A G E N D A

Architectural Review Board

February 23, 2016

1545 South Perry Street

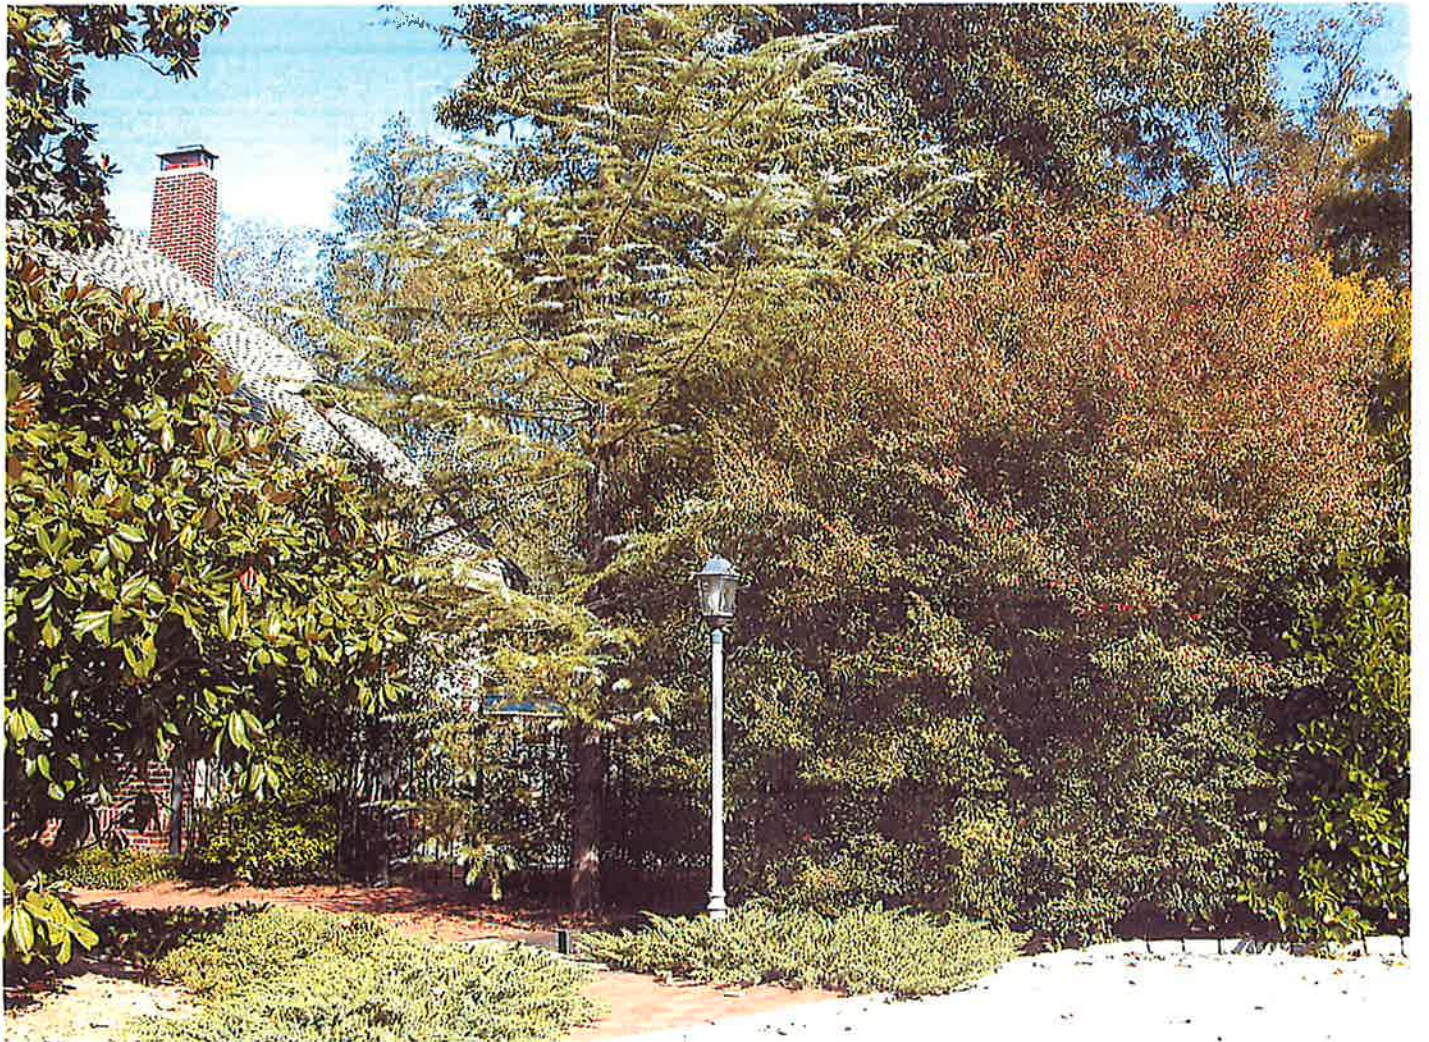
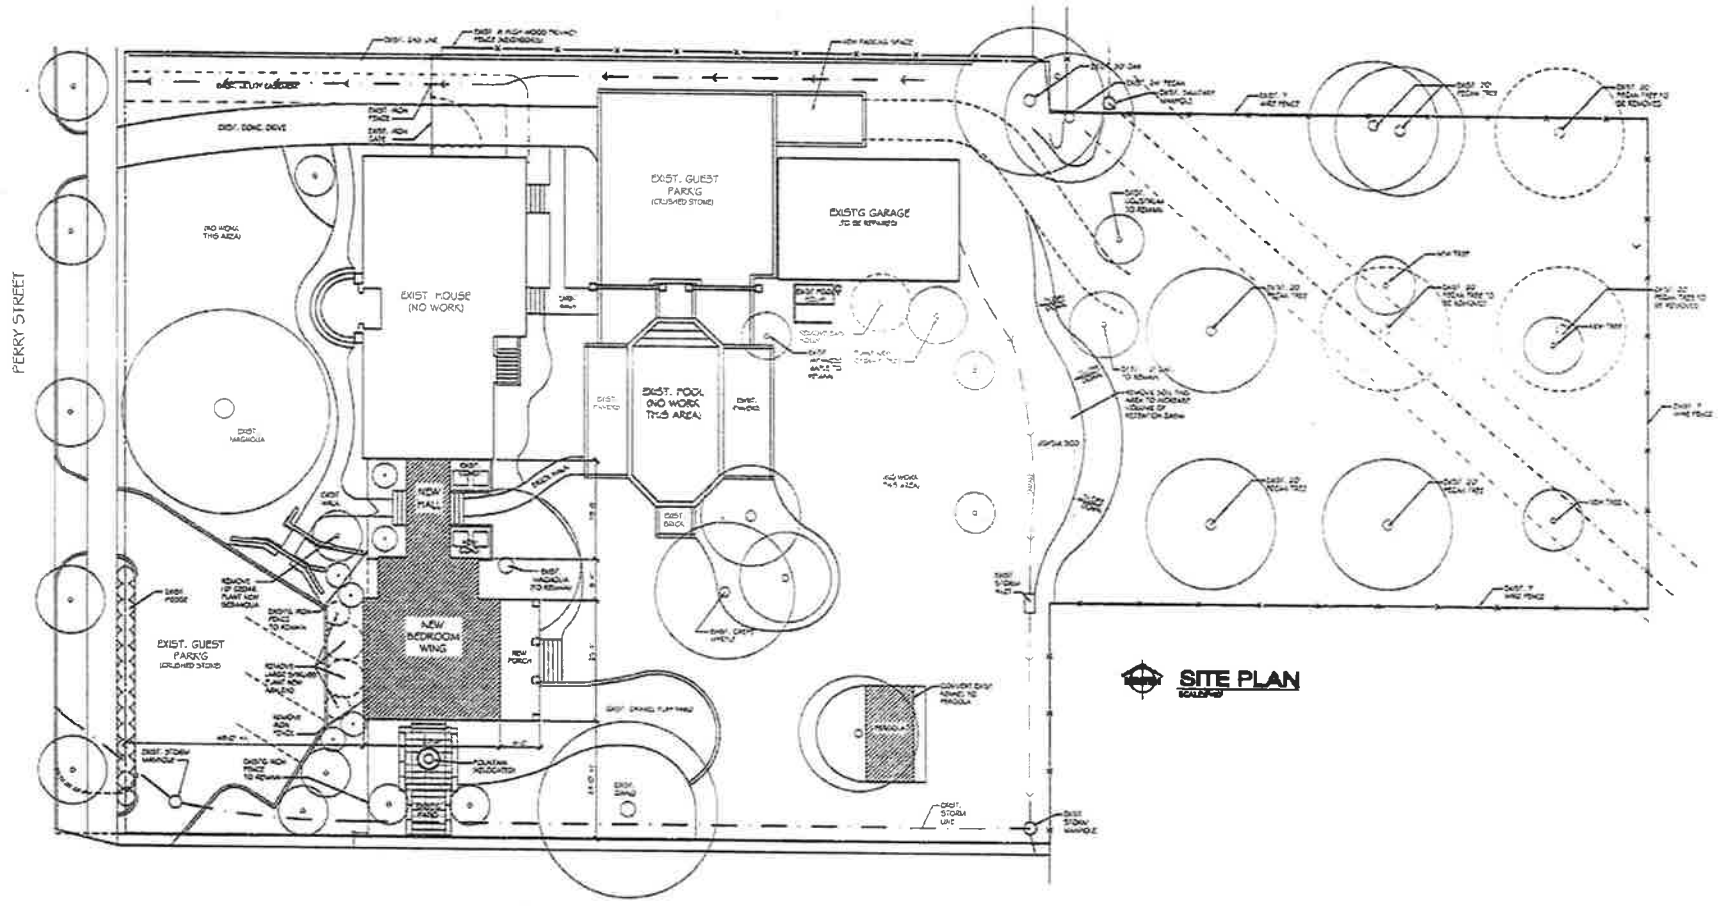
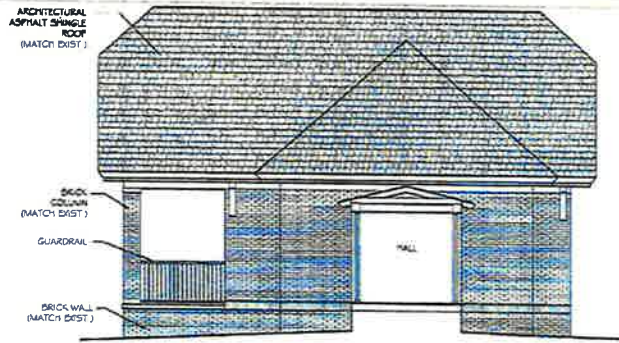
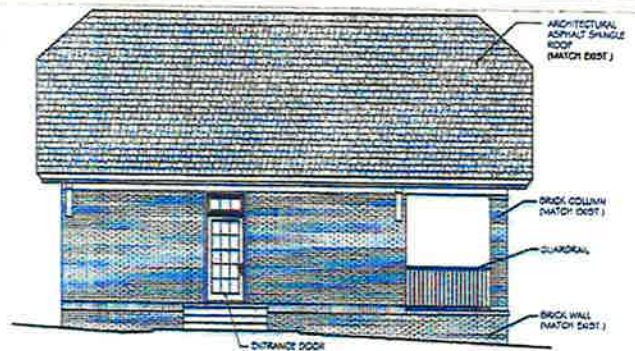
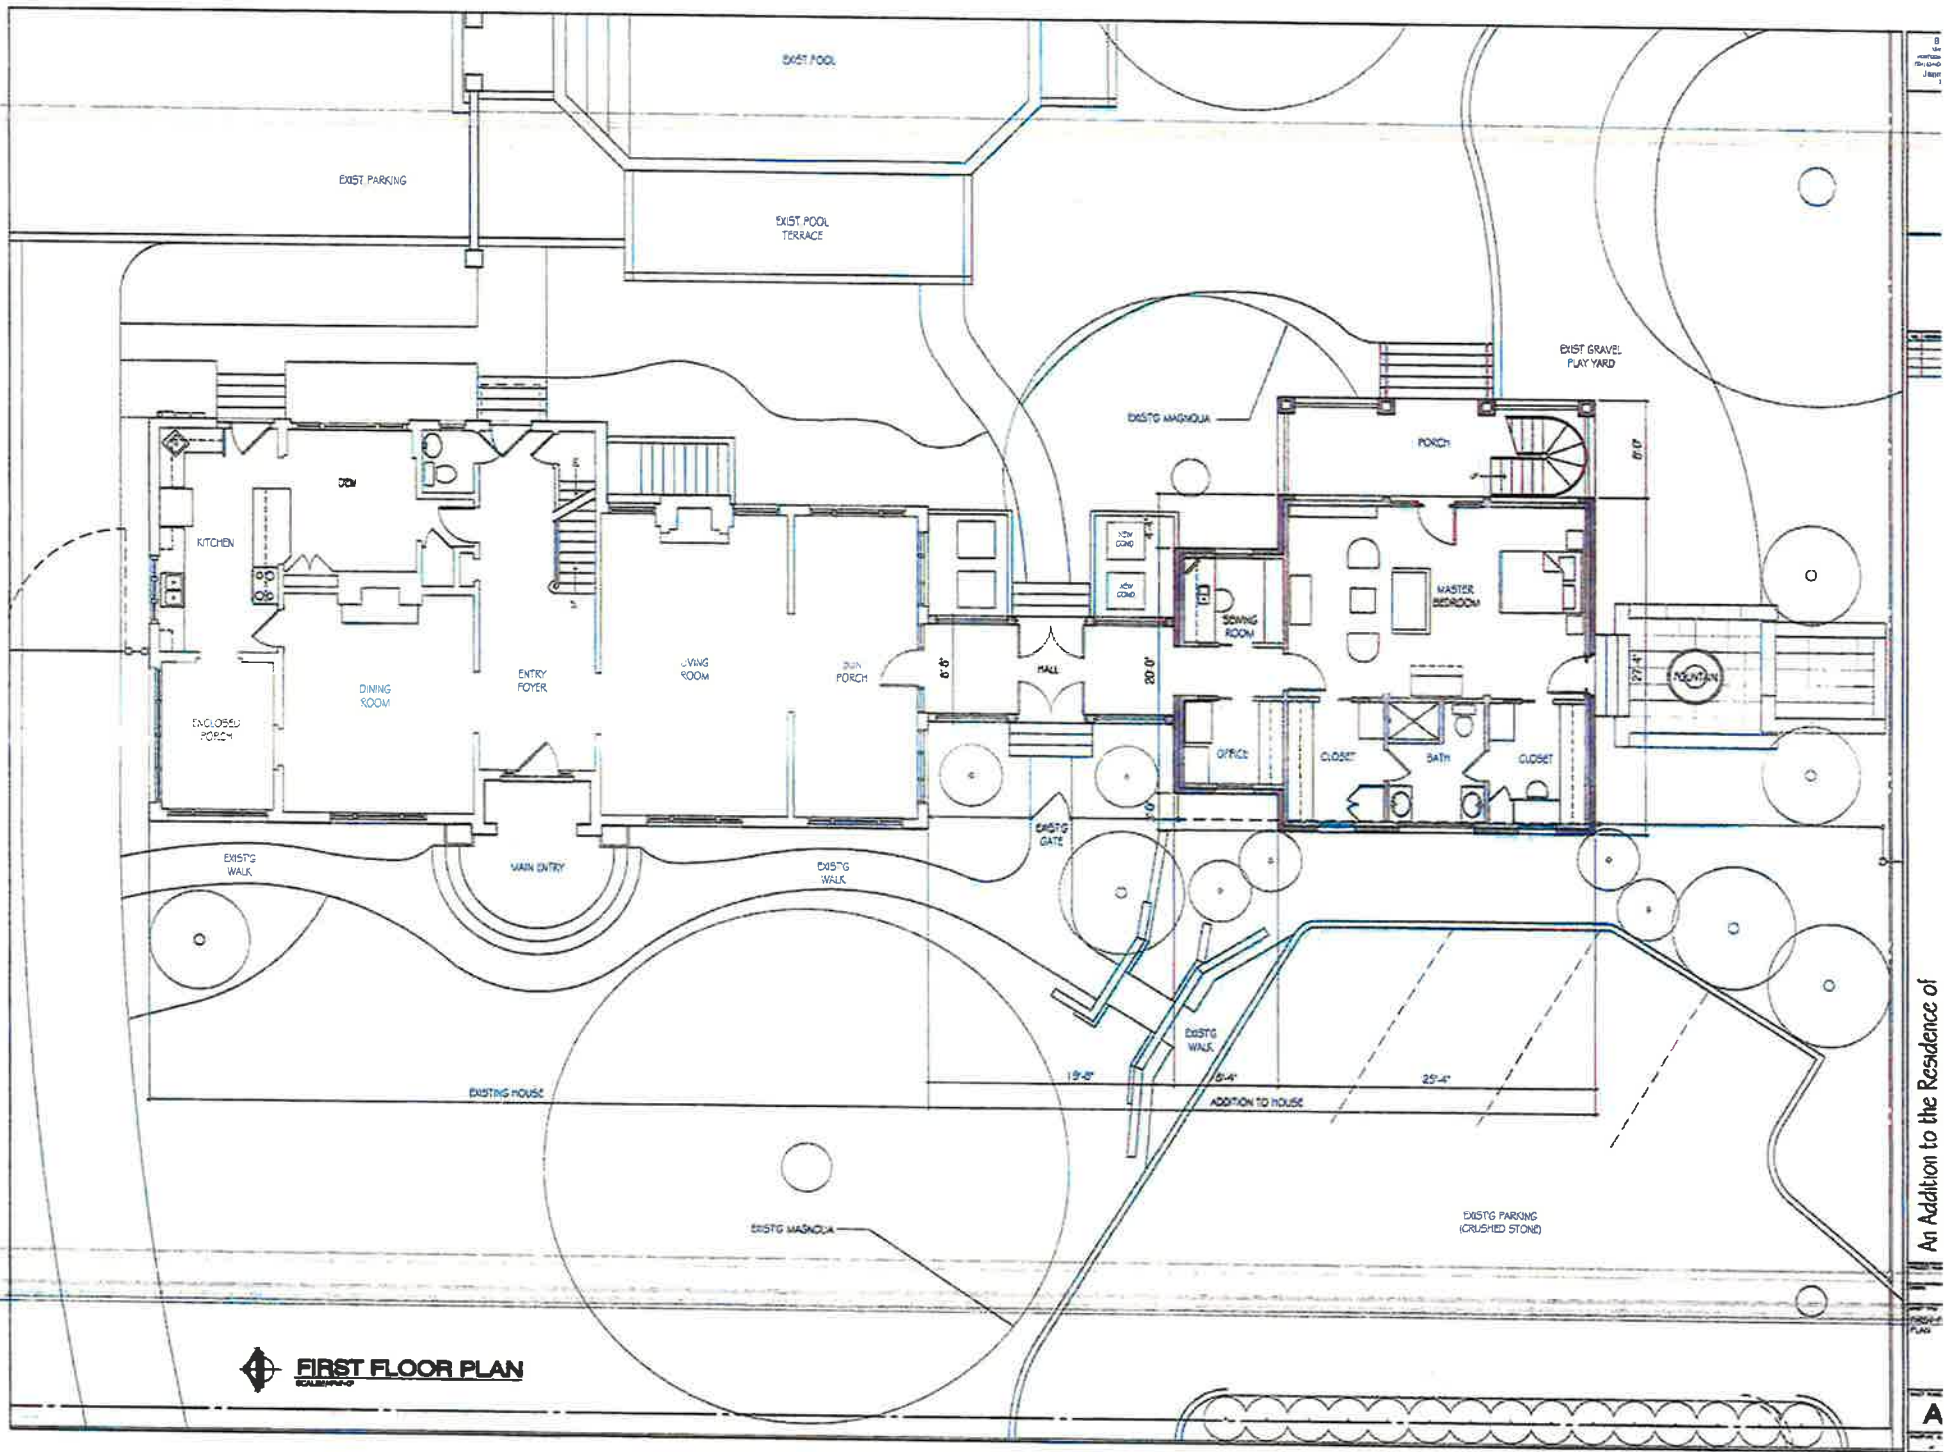
- The tree to be removed is large, healthy, and a significant part of the property.
- If removal is allowed, a large magnolia would be more appropriate for replacement.
- Plans are inserted into the agenda packet separately on 11x17 paper, the previously approved plan is attached.
